Field campaign

Topic	Tailgate hinge bolt (SC18/14)
Market area	Bentley: worldwide (2WBE),Hongkong-Macau (5HK)
Brand	Bentley
Transaction No.	2052498/3
Campaign number	EB11
Note	
Type	
US code

Bentayga

Figure 1

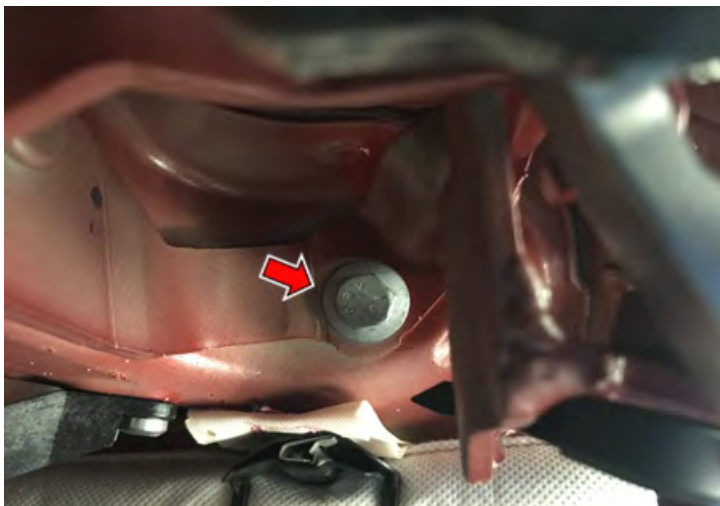
Replace the highlighted old bolt (*Figure 1*) with the highlighted new bolt **N 107 884 01** (*Figure 2*) on **both** tailgate hinges

Tightening torque for new bolt:

20 Nm + 90°

The bolt must be tightened to 20Nm + 90° and no more

The bolt must be replaced if re-torque is required
